# MegaCore IP Library

## Release Notes and Errata

RN-IP-7.3

**Figure 6-1. Corrected CPRI MII Interface Signals on Transmitting RE or REC Master and on Receiving RE Slave**

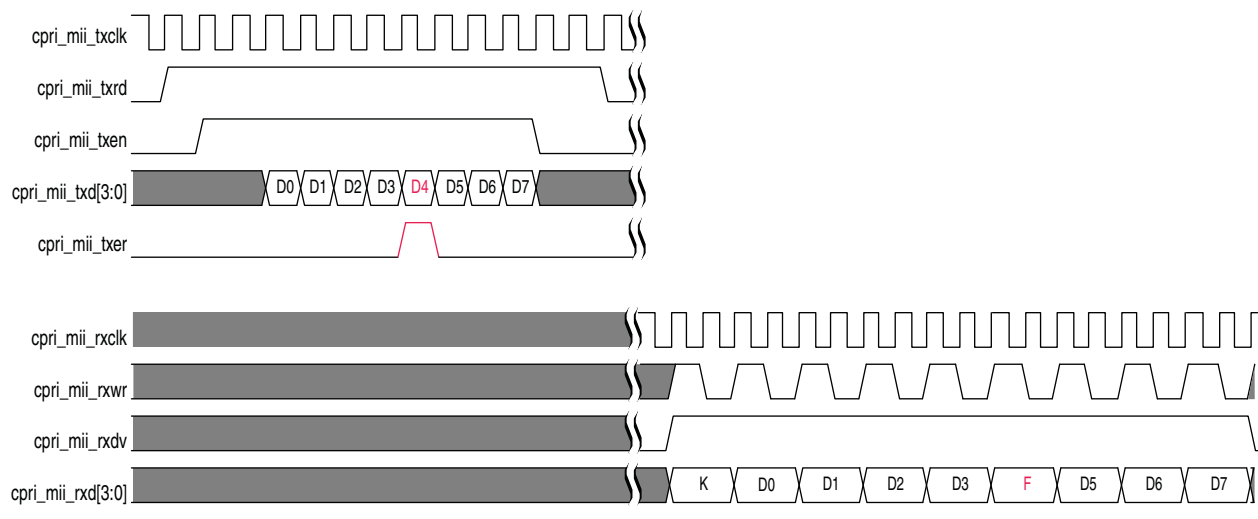
Figure 4-26, CPRI MII Interface Signals on Transmitting RE or REC Master and on Receiving RE Slave, also shows this behavior. Replace Figure 4-26 on page 80 of the *CPRI MegaCore Function User Guide* with the following [Figure 6-1](#).

Do not refer to Figure 4-23 in the CPRI MegaCore Function v10.1 User Guide. Instead, refer to Figure 4-24 and its description for correct behavior of an external Ethernet block.

**Figure 6-2. Corrected CPRI MII Interface Transmitter Example**

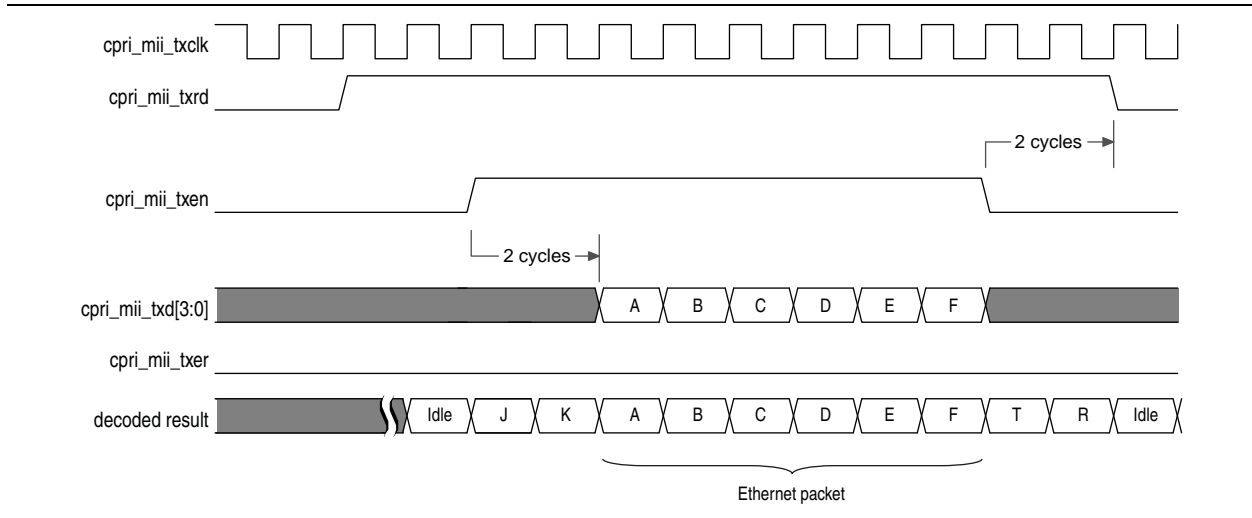
The *CPRI MegaCore Function v9.1SP1 User Guide* contains erroneous information about the MII interface. Figure 4-16 and Figure 4-17 in the *CPRI MegaCore Function User Guide* should be replaced with the figures in this erratum.

Replace Figure 4-16 on page 56 of the CPRI MegaCore Function User Guide with the following [Figure 6-2](#).

Although [Figure 6-2](#) shows `cpri_mii_txd` asserted continuously during transmission of an Ethernet packet on `cpri_mii_txd`, this is not always the case. The CPRI MII Interface transmitter can deassert `cpri_mii_txd` while `cpri_mii_txen` is still asserted, to backpressure the external Ethernet block. If this happens, the Ethernet block must deassert `cpri_mii_txen` on the following cycle, to prevent the MII Interface transmitter buffer from overflowing. The `cpri_mii_txen` signal should remain deasserted until the cycle following reassertion of `cpri_mii_txd`. If `cpri_mii_txen` is not reasserted in the cycle following the reassertion of `cpri_mii_txd`, then an Idle cycle is inserted in the packet; therefore, the external Ethernet block must reassert `cpri_mii_txen` in the cycle following reassertion of `cpri_mii_txd`.

**Figure 6-3. Corrected CPRI MII Interface Receiver Example**

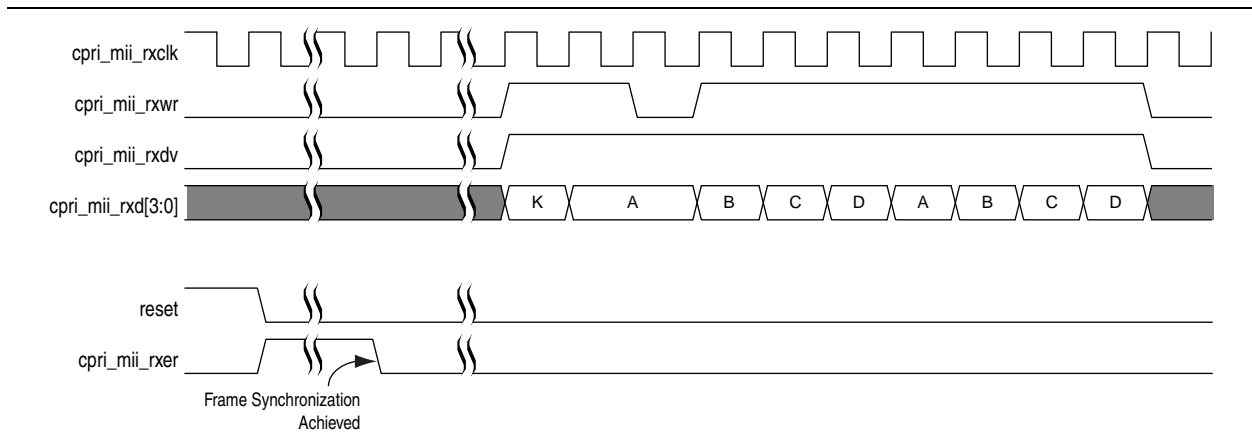
The CPRI MII Interface receiver transmits the K nibble to indicate start-of-frame on the MII interface. Replace Figure 4-17 on page 57 of the CPRI MegaCore Function User Guide with the following [Figure 6-3](#).

The J nibble of the start-of-frame is consumed by the CPRI MegaCore function, and is not transmitted on the MII interface.

Figure 10-1. PLL Parameter

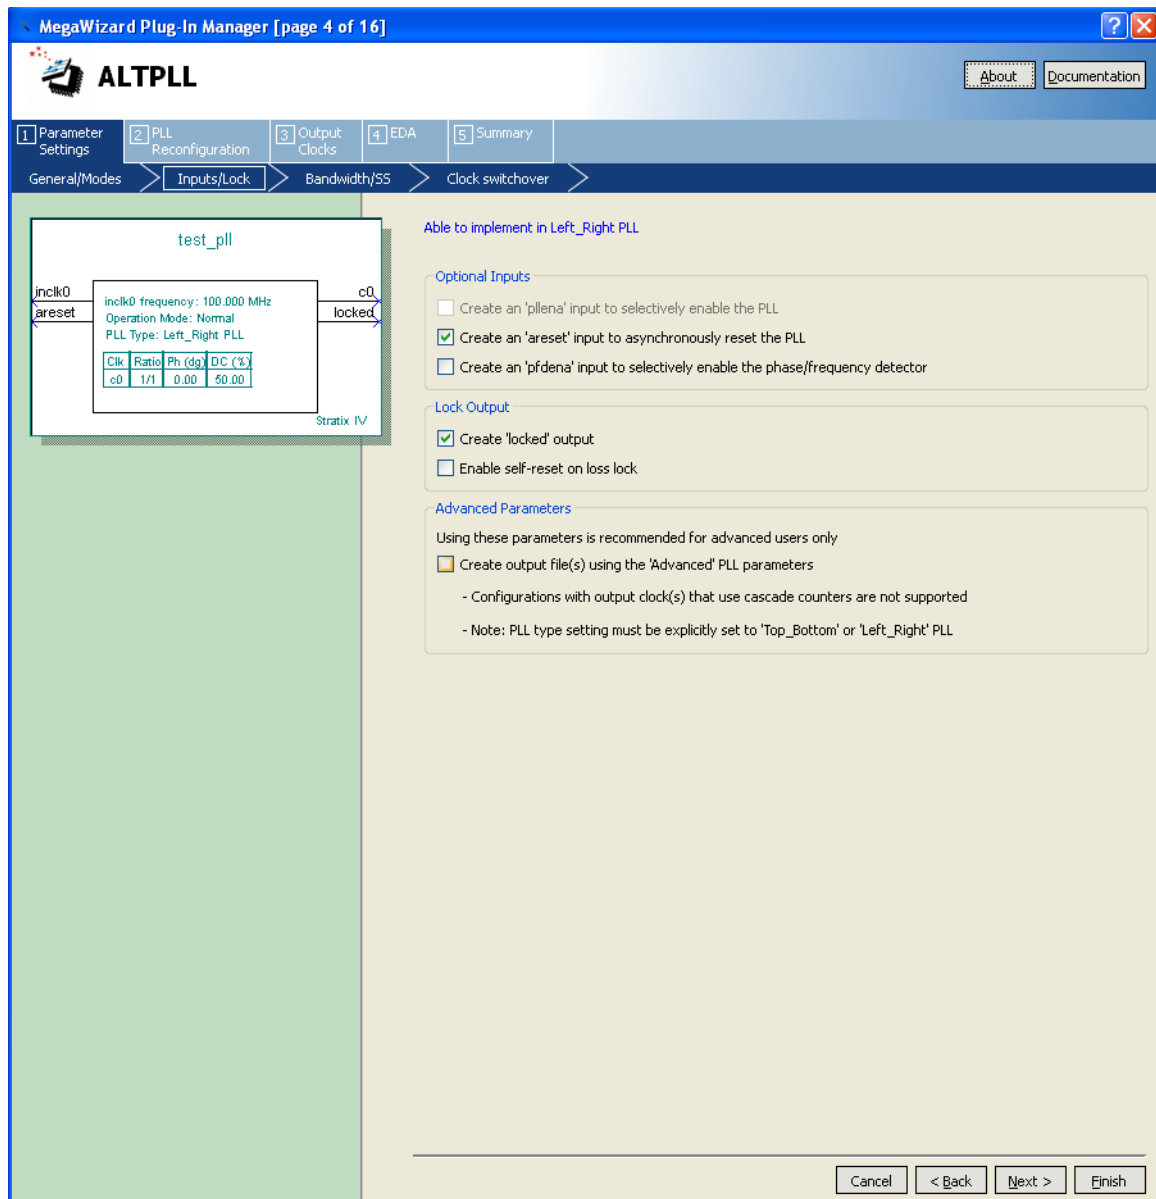
2. In the ALTPLL MegaWizard interface, turn on **Create output files using the Advanced PLL parameters** and regenerate the PLL ().

**Figure 20-1. System Port Connections**

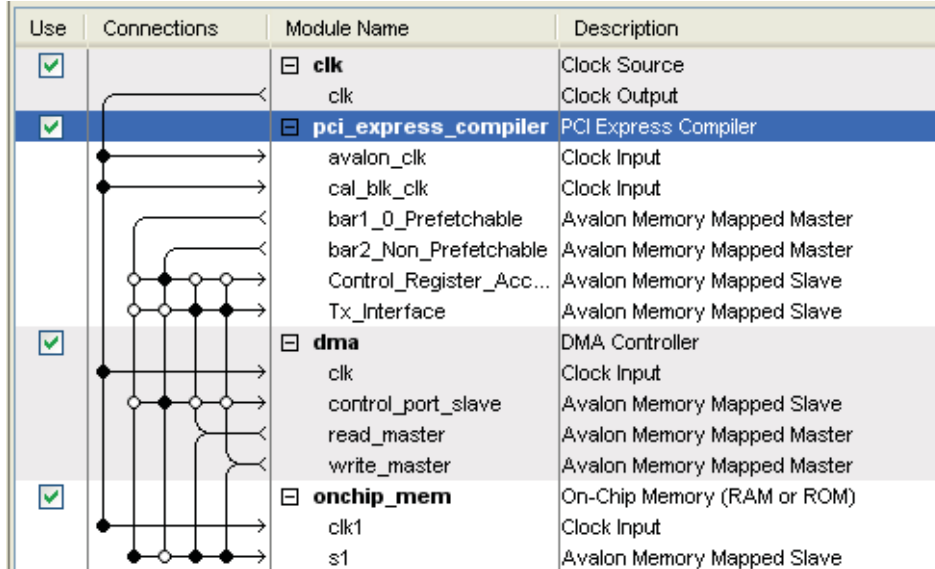
“*Figure 16-3 Port Connections*” in the *PCI Express Compiler User Guide* is missing a connection from the `dma_0 read_master` to the `onchip_memory2_0 s1`. In addition, it shows an incorrect connection from the `pcie_compiler_0 bar2_Non_Prefetchable` to `onchip_memory2_0 s1`.

This is a documentation error only. Figure 20-1 illustrates the correct connections.
